CITY OF ALBUQUERQUE

**Re: GAHP Casa Feliz
544 San Pablo
Request Permanent C.O. - Accepted
Engineer's Stamp dated: 12-18-15 (L19D073D)
Certification dated: 6-2-17**

Drainage Certification (L19D073C, DRB#1010674)

PROJECT NAME
CASA FELIZ

TYPICAL POND DETAIL

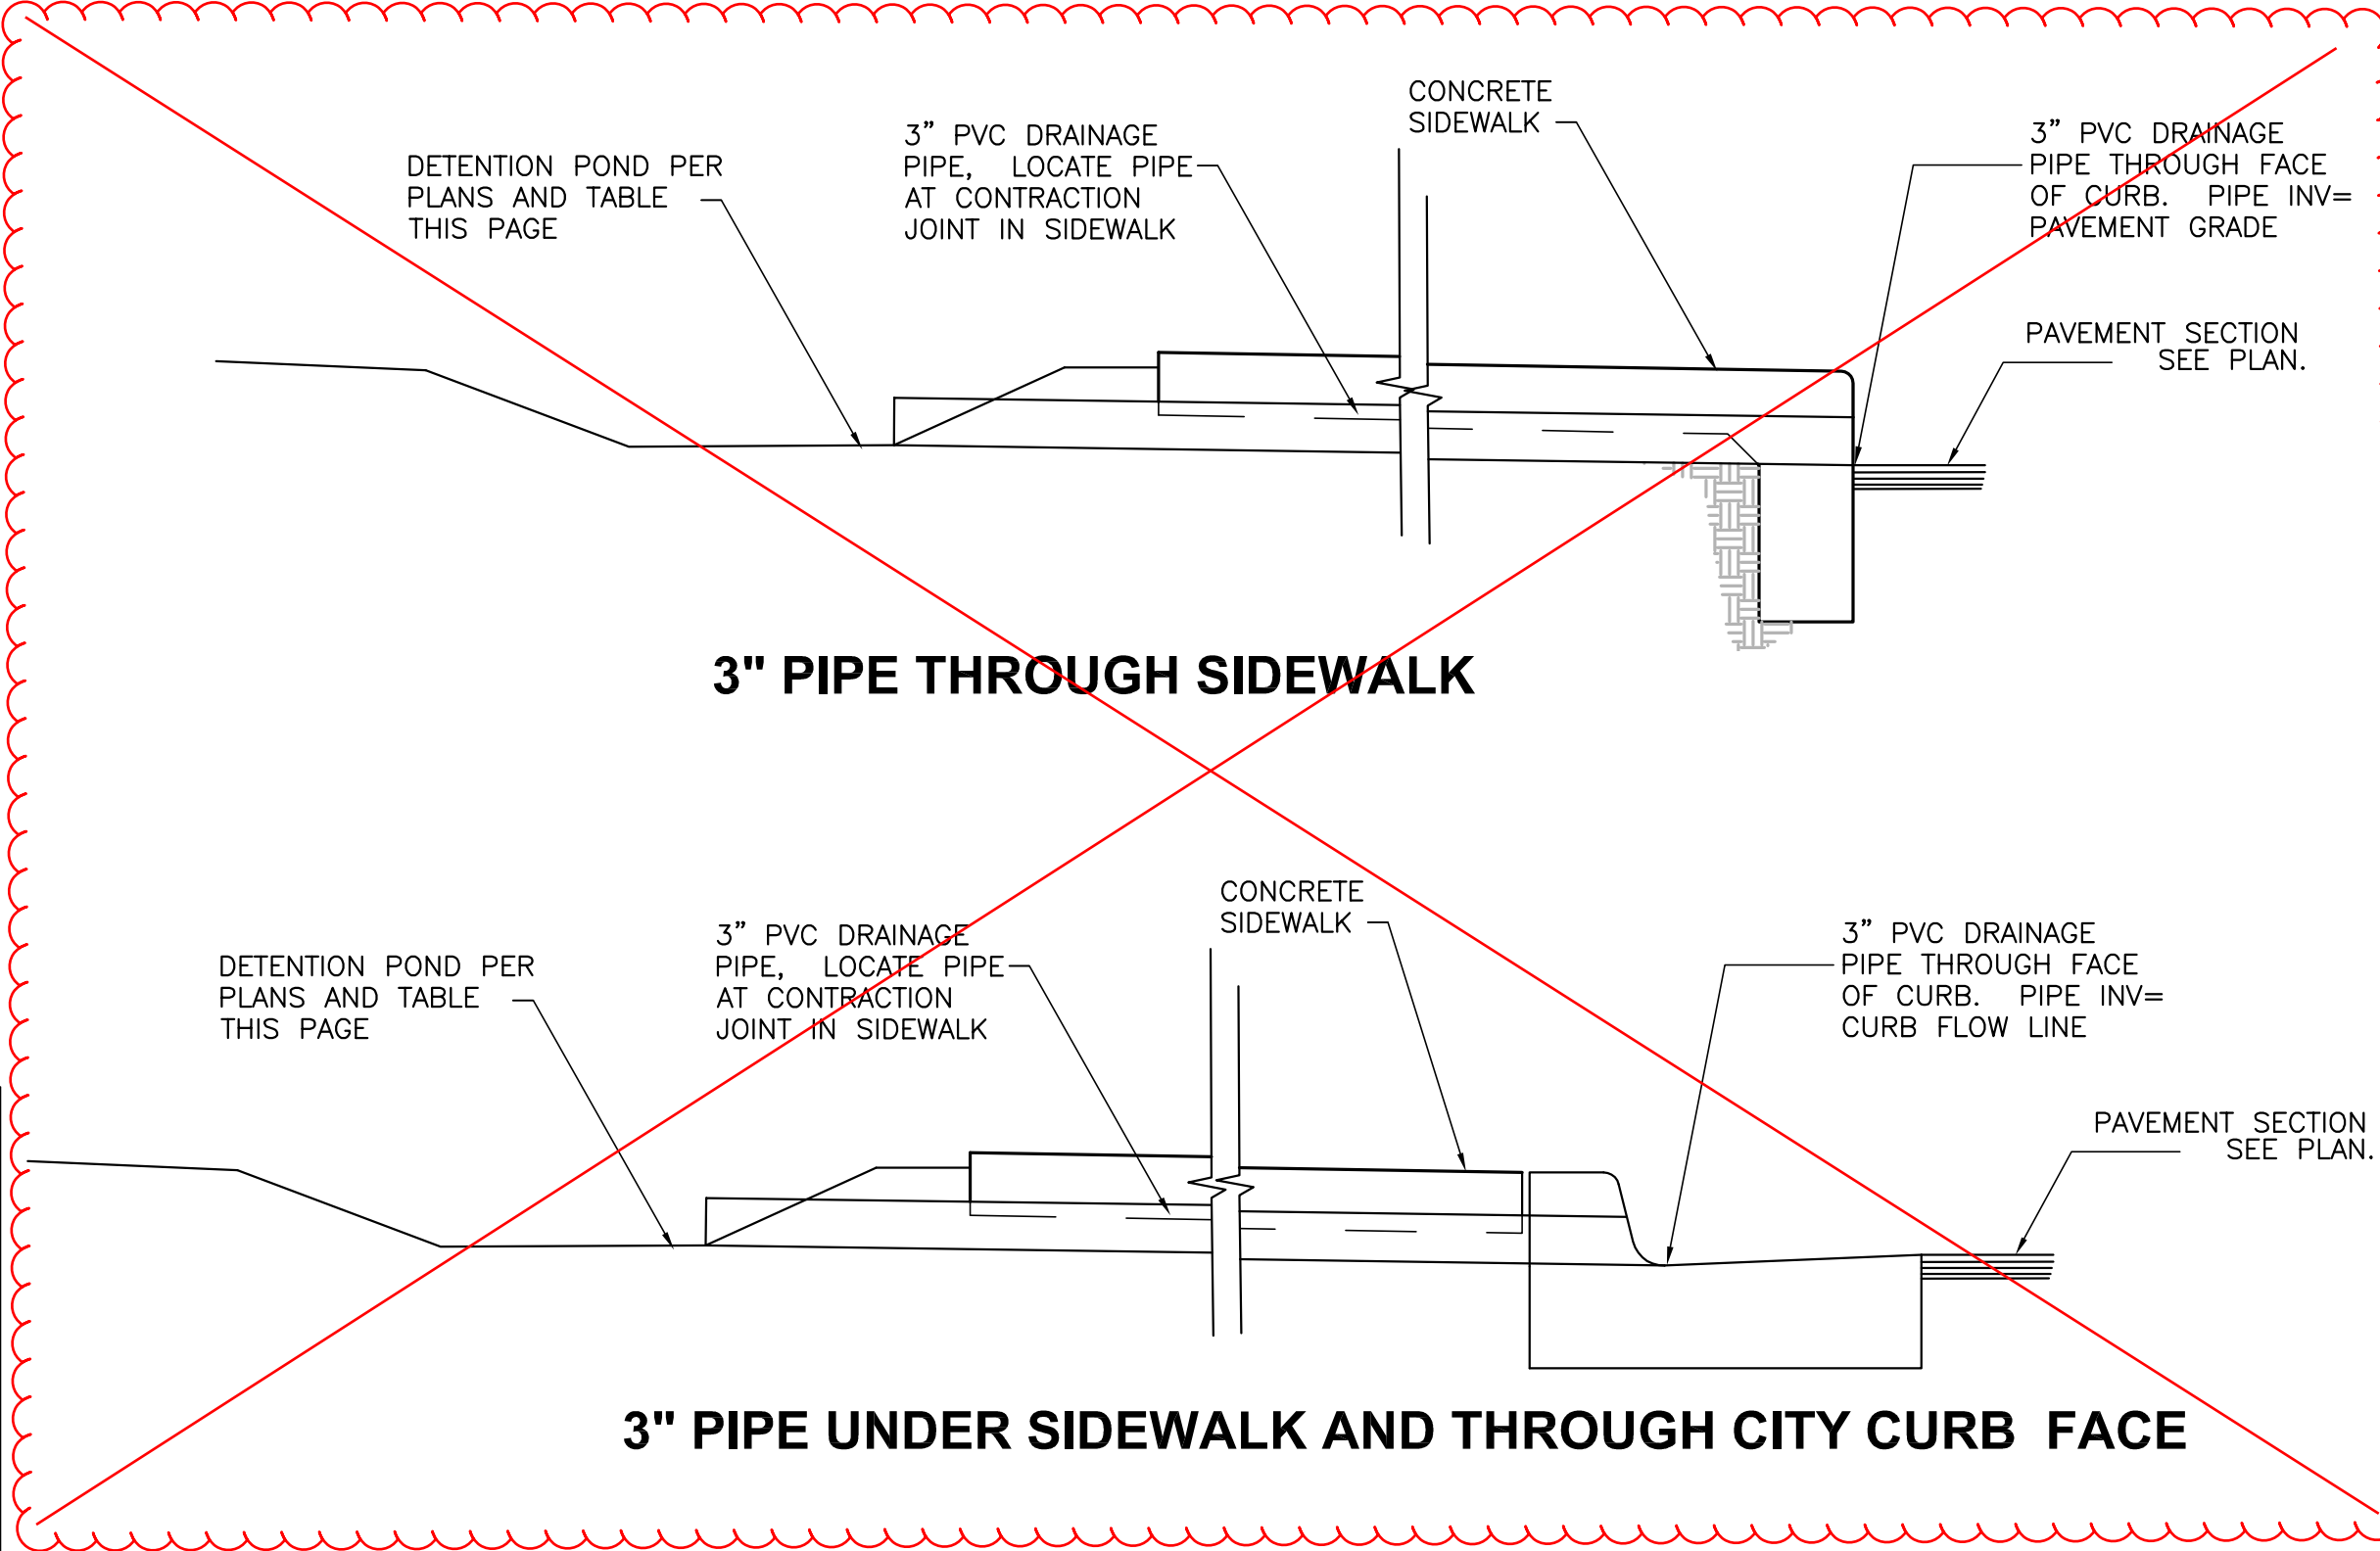
This detail requirement was removed after release of the building permit. Please refer to the email correspondence with City of Albuquerque Hydrology Staff dated May 3, 2016 attached with this submittal.
